**City of Ann Arbor
Lower Town Mobility Study
Road Safety Audit**

FINAL REPORT

July 2020

Road Safety Audit

Figure 18: Traver Rd Sidewalk Gap Between John A Wood and Barton Dr

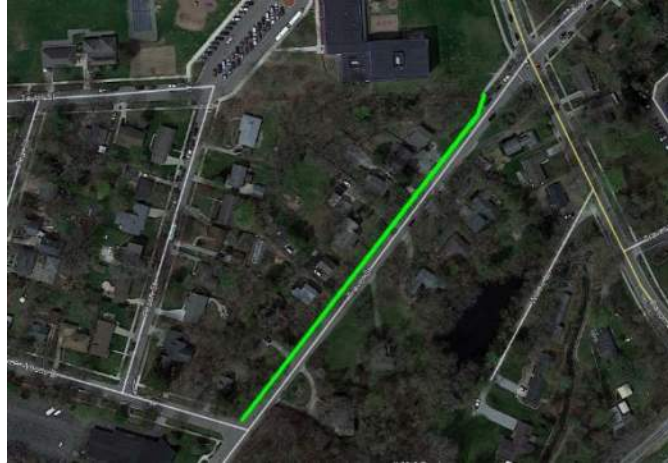
- Traver Road: Construct sidewalk between John A Wood Street and Barton Drive, filling the sidewalk gap on the west side of the road. This could be accomplished by removing on-street parking along the northwest side of Traver and using the resultant space for a sidewalk and greenbelt separation from the travel lanes.

Figure 19: Broadway St Sidewalk Gap Between Plymouth Rd and Maiden Ln

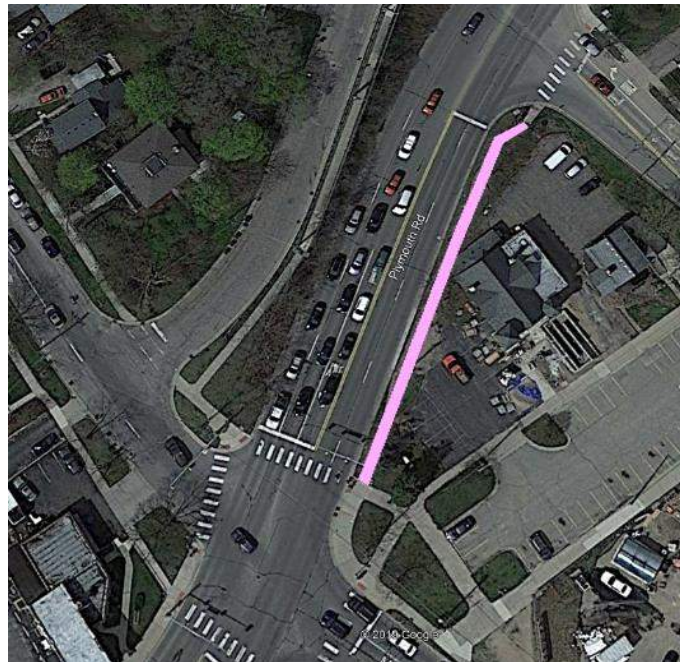
- Broadway Street: Fill the sidewalk gap from Maiden Lane to Broadway Street/Plymouth Road intersection on east side of roadway.

Figure 20: Barton Dr Sidewalk Gaps West of Starwick Dr and East of Chandler Rd. Proposed Crossing of Barton Dr West of Chandler Rd.

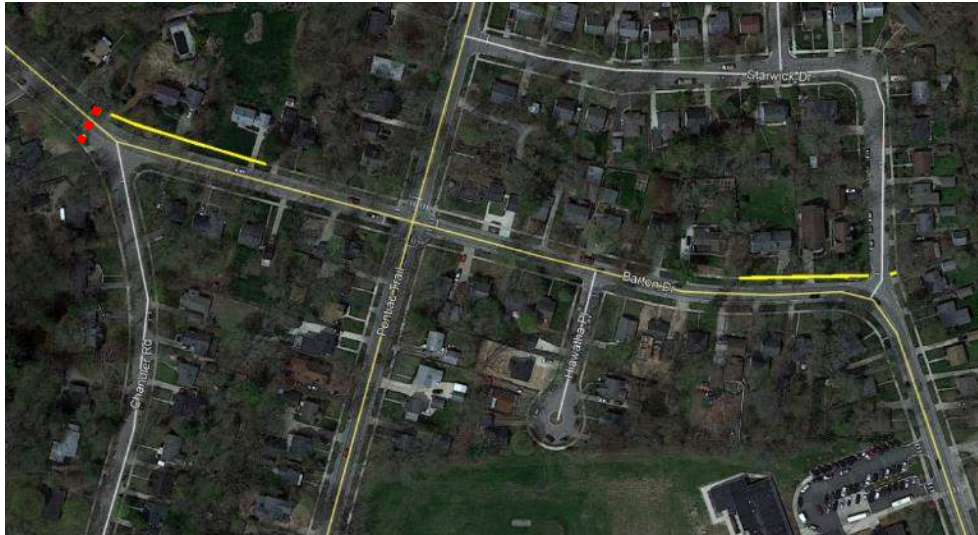
- Barton Drive: Fill the sidewalk gaps near Starwick Drive and Chandler Road to connect to the existing sidewalks.
- Barton Drive: Provide a connection from north to south to access the boardwalk at Brede Place

Figure 34: Alternate Route (Blue) From Overflow Parking to Cascade Headwaters

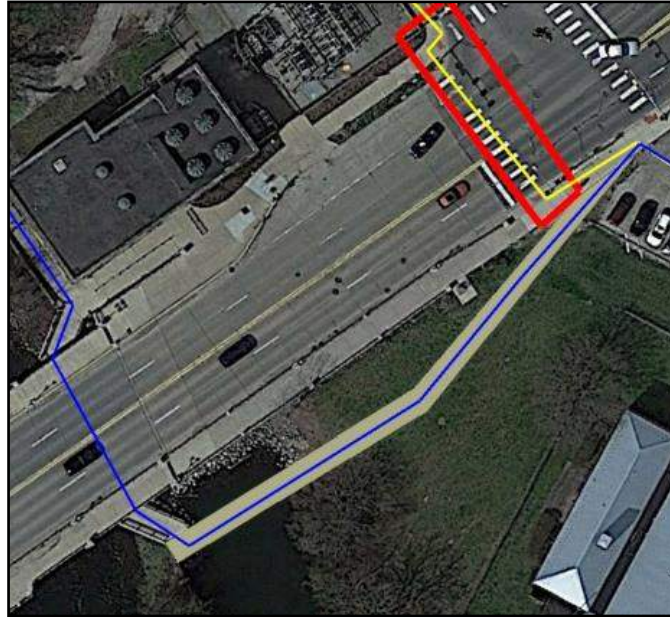
- Adding a connection from the south side of Broadway Street to the Border to Border Trail/Riverwalk would reduce pedestrians crossing over Broadway. The Riverwalk provides access under the Broadway Street bridge and ties directly into the pathway on the south side of the Cascades.

Figure 38: Relocating the pedestrian crossing would improve sight lines for both drivers and pedestrians with each other.

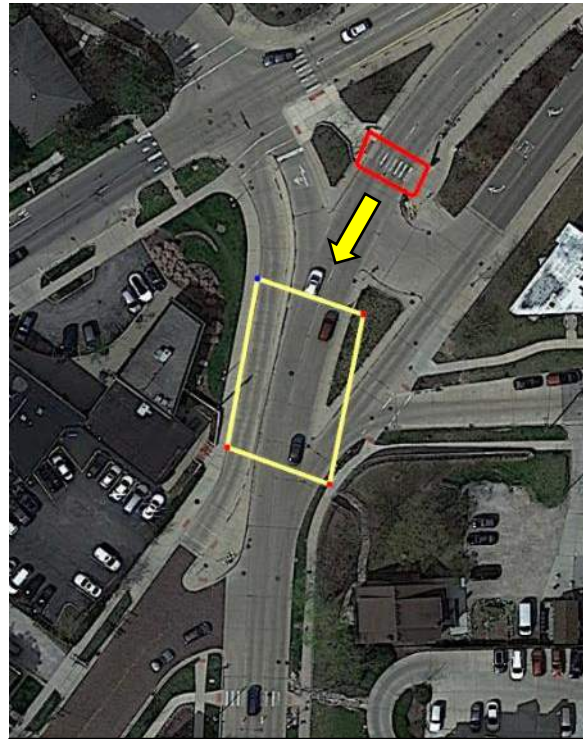
- The intersection of Division Street with Carey Street, Detroit Street, Broadway Street, Beakes Street and Summit Street should be reconfigured to improve safety, slow vehicles down, and make pedestrian crossing easier.
- The northern pedestrian crossing at Carey Street should be relocated to enhance visibility (from red box to yellow box in image)
- Add in road gateway treatments R1-6 to crossing areas
- Narrow the lanes to slow vehicles down

Figure 47: A train consisting of about 60 freight cars (green line) would block all the rail crossings in Lower Town, leading to extensive backups (red lines).

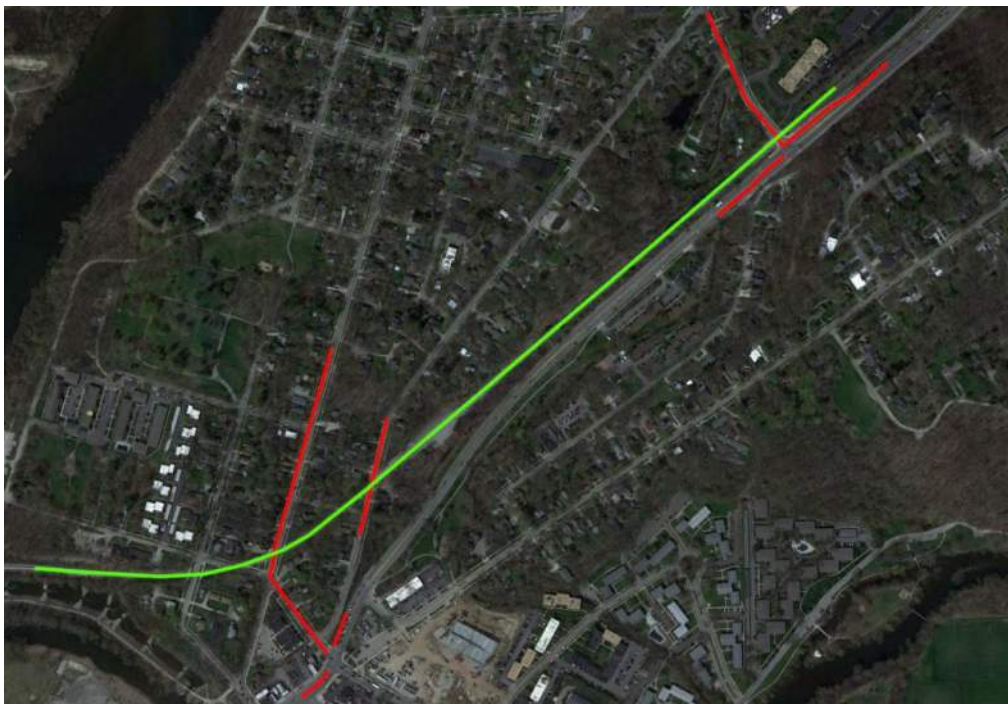
- Multiple locations within the Study Area experience congestion when freight trains pass through.
- Backups happen at Barton Drive, Traver Road, Pontiac Trail, and Moore Street.

Figure 46: The Ann Arbor Railroad freight train routinely impact the a.m. commuter period, resulting in significant queues that take protracted time to clear.

- Review and potentially add traffic signal pre-emption
- Review vehicle storage needs during train events
- Consider an ITS-based changeable message signs for NB and SB M-14 tied to a RR pre-emption to advise drivers of train's presence and advise them to find alternate routes.

Figure 56: Example of how filler walls can eliminate (right side) or minimize (left side) protuberances that could snag bicyclists.

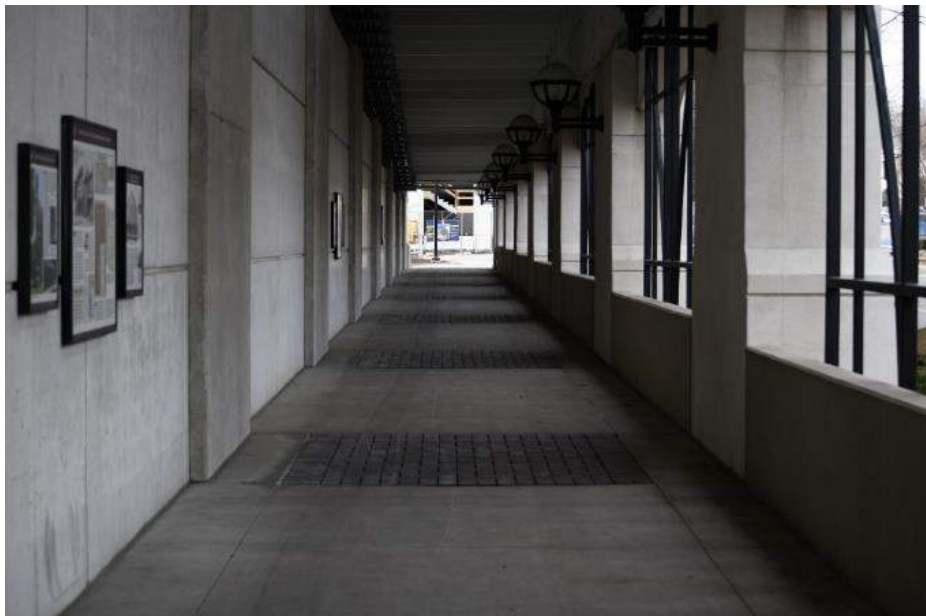
Figure 52: Broadway Street bridge has poor visibility around the curve at Division Street and concrete pillars holding light poles extend too far into the travel way. Concrete fillers should be placed to eliminate the protrusions of the bridge and lighting posts, presenting a smooth barrier face to cyclists.

- Add bike lanes to Barton Drive from Pontiac Trail to Huron Bridge Park
- Add bike lane to Broadway Street bridge or adjust light pole pillars to be flush with the bridge's sidewalk.
- Widen bike lanes adjacent to parking areas by reducing travel lane width and delineating limits to the parking area.
- Increase enforcement and citations of obstacles blocking bike lanes

Figure 63: Provide guidance from Chandler Av to bike route on Hilldale Dr (2016 Ann Arbor and Washtenaw County Bike Map).

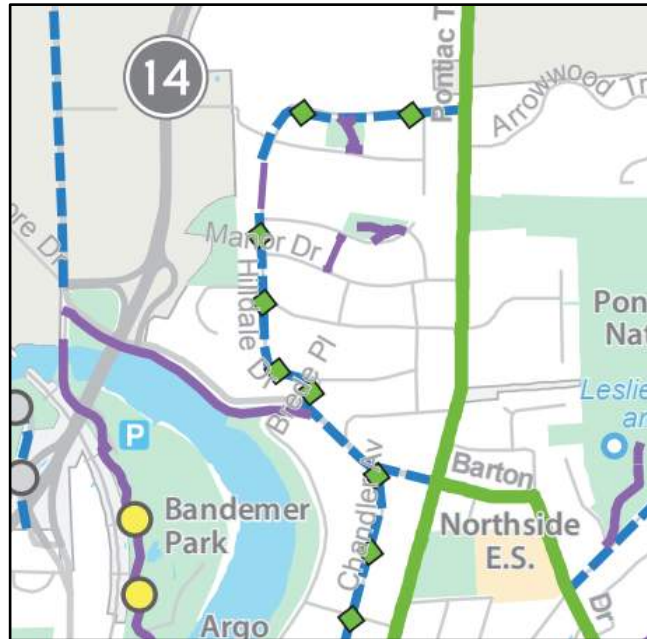
Figure 61: The bike route on Chandler Road does not lead to a bicycle facility and only designates Chandler Road as a safe bicycle street. There are few other signs and the signs are lacking arrows pointing where the bike route continues.

- Provide a bicycle facility on Barton Drive that would connect to the existing bike lanes on Barton Drive at Pontiac Trail and continue west to Huron Bridge Park.

Figure 86: Install box span-wire mounted or mast arm mounted signals to improve visibility and safety.

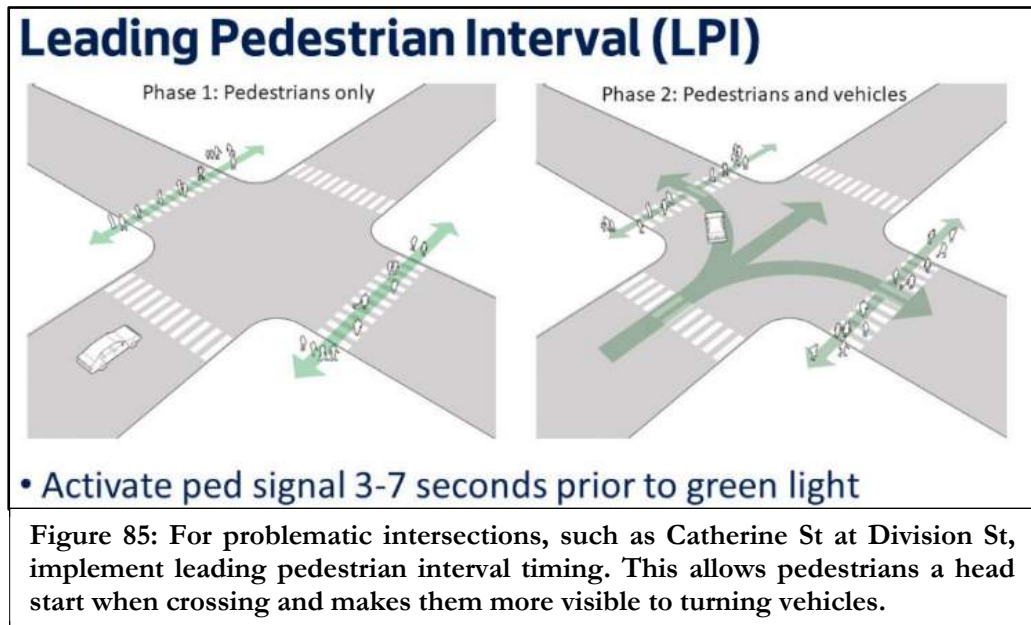
Figure 83: Outdated diagonal span-wire mounted traffic signals should be considered for modernization.

Figure 90: The south and east legs of intersection are one-way streets. Various allowed movements are depicted.

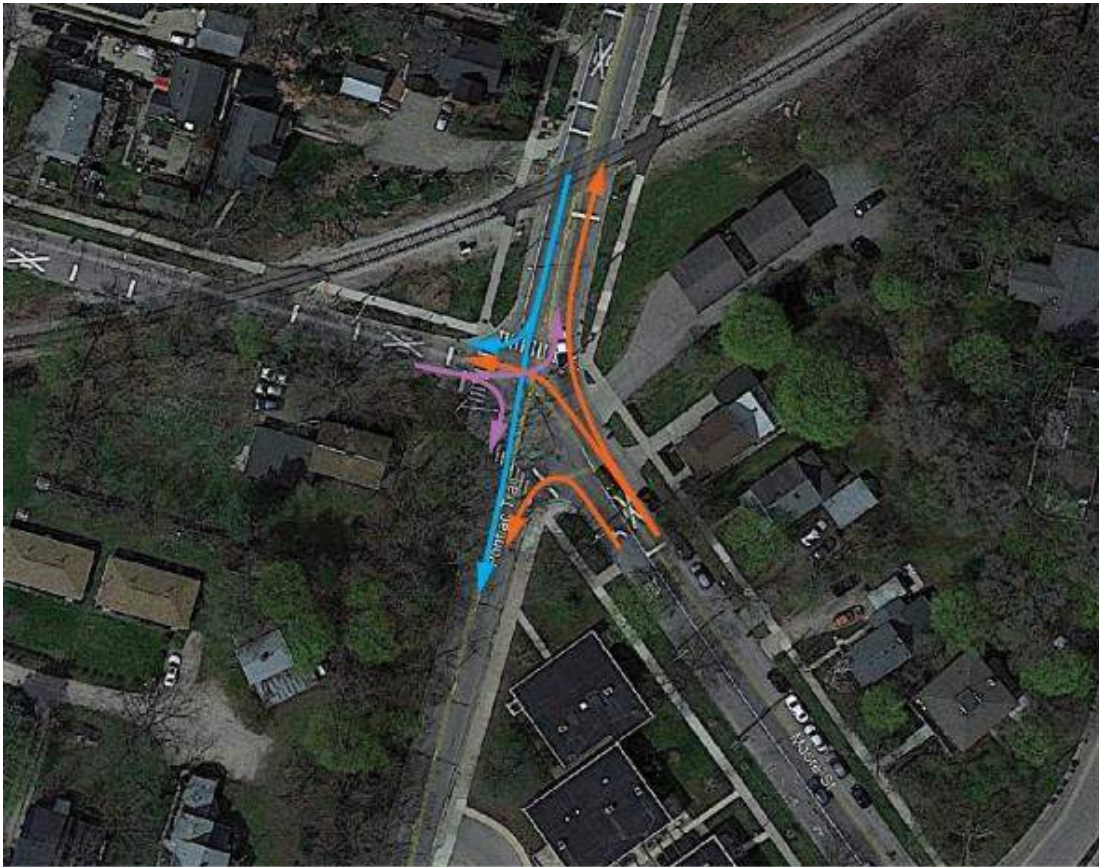
- Skewed intersection with main route northbound turning through the intersection
- One-way pair for southern legs of intersection to access/come from Plymouth Road/Broadway Street
- Unusual traffic control devices, including flashing yellow and red signals facing Moore Street
- Railroad tracks located just north of the intersection
- Wrong way movements observed by team

Figure 93: Mid-Term Option A – Add new islands to intersection. Stop signs would be added for Moore Street to Longshore Drive movement. Traffic signals would be

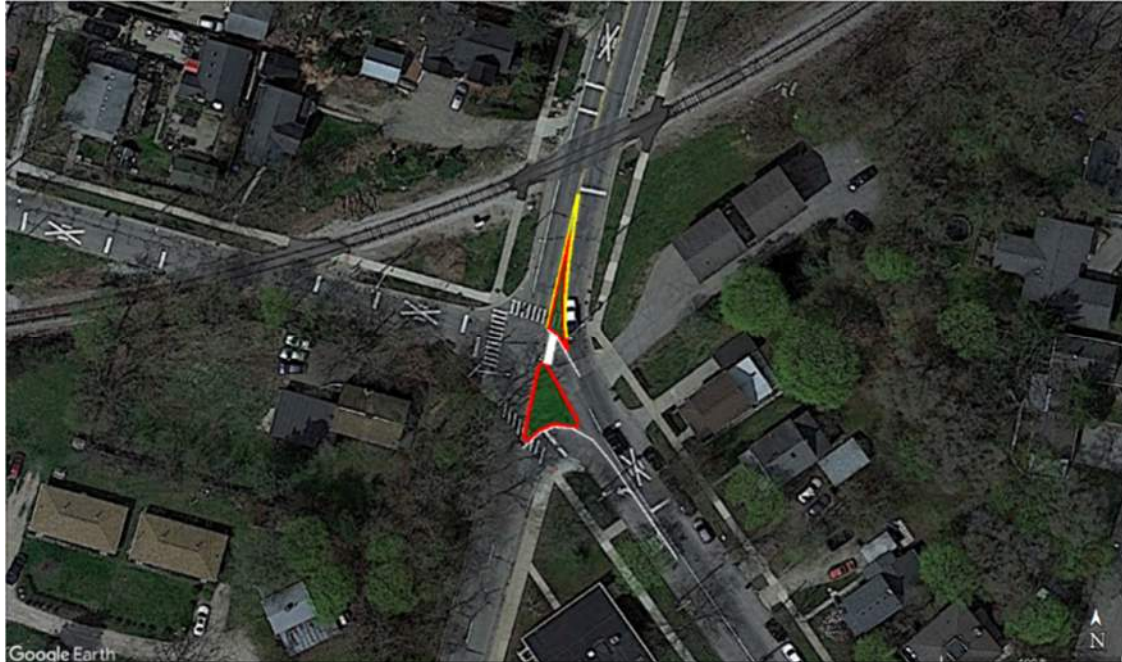
- Add and/or enhance traffic islands and remove signals

Figure 100: Convert Maiden Ln and Wall St to one-way pair. Option B: Shift western portion of Wall St to align with Swift St at signalized intersection and eastern portion uses new Huron River bridge to rejoin Maiden Ln at Fuller Rd. Otherwise same benefits as Option A.

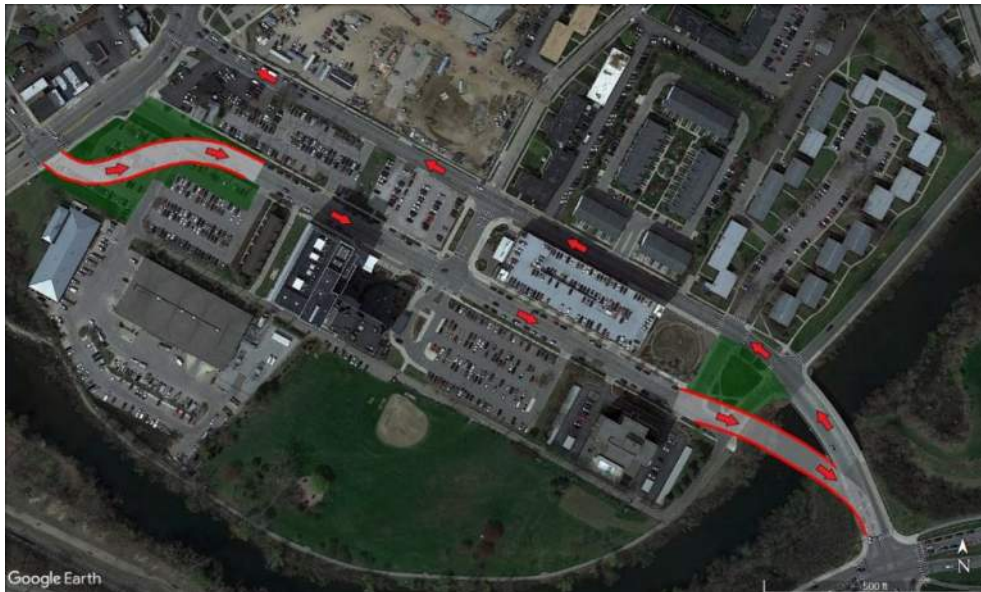
- Canal Street would become one-way, in southeast direction, or be reclassified to an alley.

Figure 104: Option A – Close access between Detroit / Division and Broadway / Summit. This would eliminate conflicts with pedestrians crossing Beakes St and Broadway St. Crosswalk would be moved south along Division to improve visibility around the retaining wall.

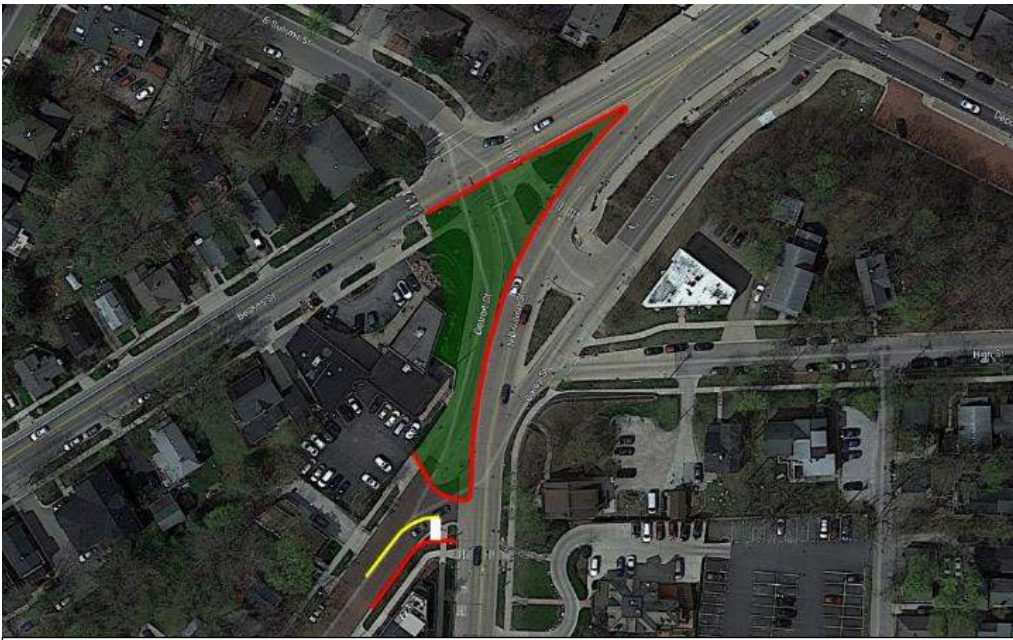
- Option A: Close Detroit Street south of Beakes Street using a median island extension

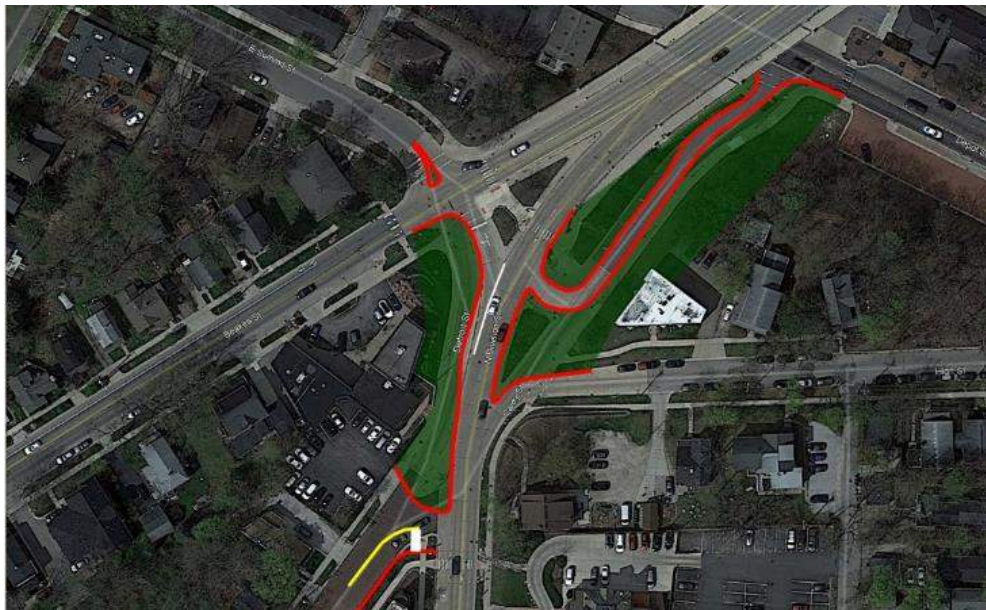
- Option C: Close northbound entrance to Carey Street from Division Street and southbound access to Detroit Street from Broadway Street/Summit Street.

Figure 106: Option C – Close northbound entrance to Carey St from Division St and southbound access to Detroit St from Broadway St/Summit St. Maintains access from Division to Summit. Left turns and thru movements would be channelized. Would maintain access to the Broadway Street bridge from Depot Street and to High Street from Division.
